S U B M I S S I O N: Luong-Le
a written submission by way of further objection to REV 2021 0034
Section 8.2(1A) Review of Determination

231 Whale Beach Road Whale Beach 2107
REV 2021/0034
Section 8.2(1A) Review of Determination - Review of Determination of Application DA2020/0442
for demolition works and construction of a Mixed-Use Development comprising Shop Top Housing
and retail premises, with associated carparking, landscaping and strata subdivision

Marked-up Roof Plan: Zone in excess of 8.5m building height: the excessive height above 8.5m is not 'minor' and fails LEP 4.3 2D [a], and fails the objectives LEP 4.3 [1] [a] desired character of locality, [b] compatible with neighbours, [c] overshadowing, and [d] view.

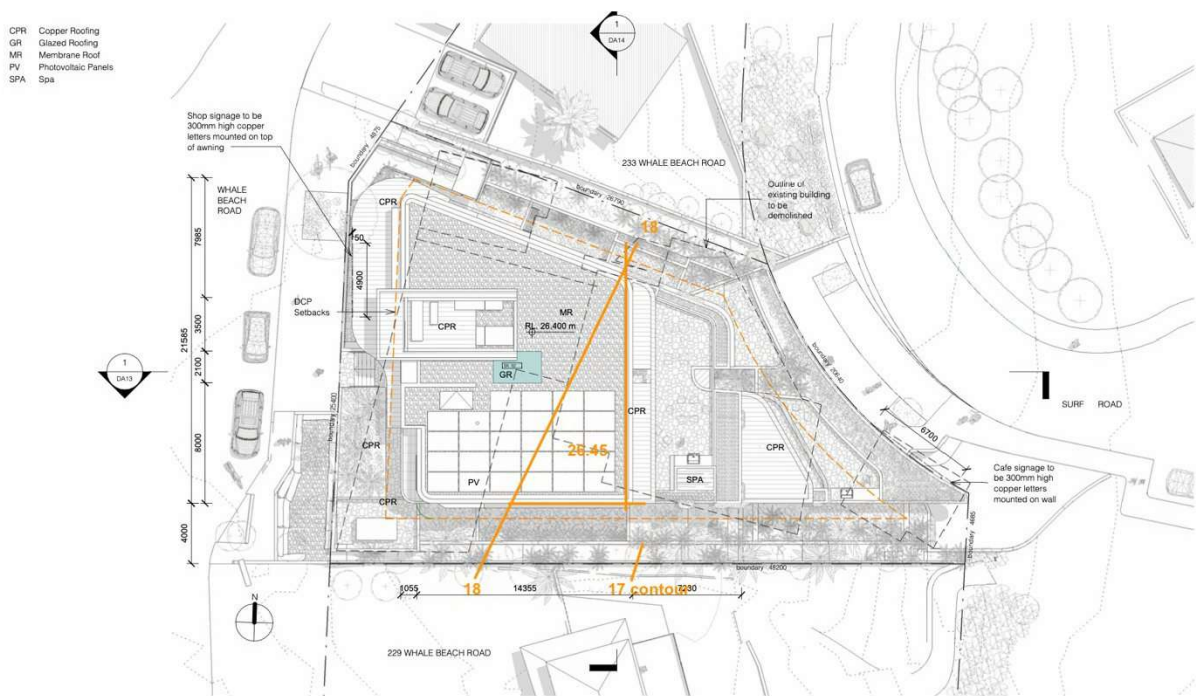
We are disturbed to find a misrepresentation of Heights of Buildings with the *envelope blankets* clearly not aligning with the Registered Surveyors spot levels on the survey.

The Building Height is 9.5m, representing a 12% non-compliance to the 8.5m height. No variation has been sort under Clause 4.6.

The south-east corner of the Level 4 is positioned well above the 8.5m building height, contrary to the Applicants drawings. The excessive height extends along the southern boundary at Level 4 by up to 8m in length, and extends across the entire eastern 16m edge of the proposed roof.

The Registered Surveyors drawings show the 17m contour and a multitude of spot levels between 17m and 18m along the proposed development's southern flank.

The Applicants Height Blanket drawings are unfortunately false and misleading.

The excessive roof zone above 8.5m is a triangular section covering an area of c 65sqm of the south-east corner of Level 4. It is this zone that we contend is unacceptable.

We contend that the excessive height above 8.5m is not 'minor' and **fails LEP 4.3 2D [a]**, and fails the objectives **LEP 4.3 [1] [a] desired character of locality, [b] compatible with neighbours, [c] overshadowing, and [d] view.**

1. Lower the entire built form by 1m. Proposed south-east corner of the roof, sits adjacent to the RL 17.0 Contour. Reduce the Roof Parapet to RL 25.5 to maintain 8.5m building height. Alternatively remove the non-compliant zone above 8.5m building height by greater terracing and a reduced upper level floor plate.

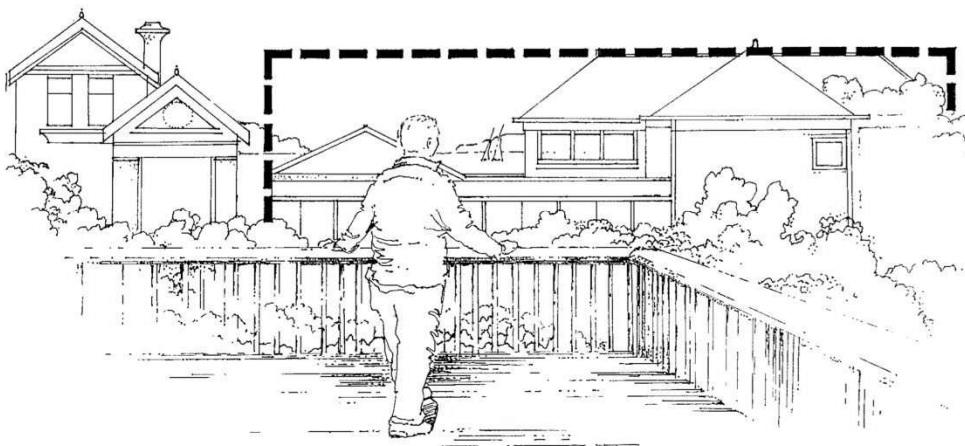
As the proposed development does not comply with outcomes and controls, that are the most relevant to visual impacts, greater weight would be attributed to the effects caused.

In our opinion the extent of view loss considered to be **moderate**, in relation to the views from our living rooms and living room deck of our dwelling, particularly to the east. The view is from a location from which it would be reasonable to expect that the existing view, particularly of the water could be retained especially in the context of a development that does not comply with outcomes and controls.
